1984-1986 JEEP WAGONEER/TRUCK

## **MODEL 208 TRANSFER CASE REVISION ANNULUS GEAR**

86493A

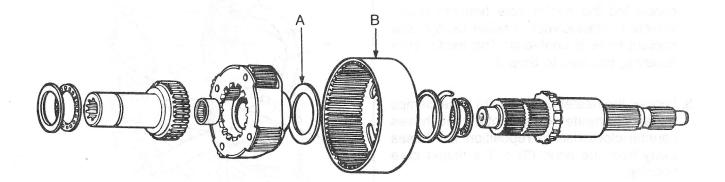
Two annulus gear assemblies were used in Model 208 transfer cases. They are interchangeable.

Type I has a metal hub annulus and does require a thrust washer.

Type II has a nylon hub annulus and does not require a thrust washer.

When replacing a Type I annulus gear with a Type II annulus gear (B), be sure to discard the thrust washer (A) located between the annulus and planetary gears.
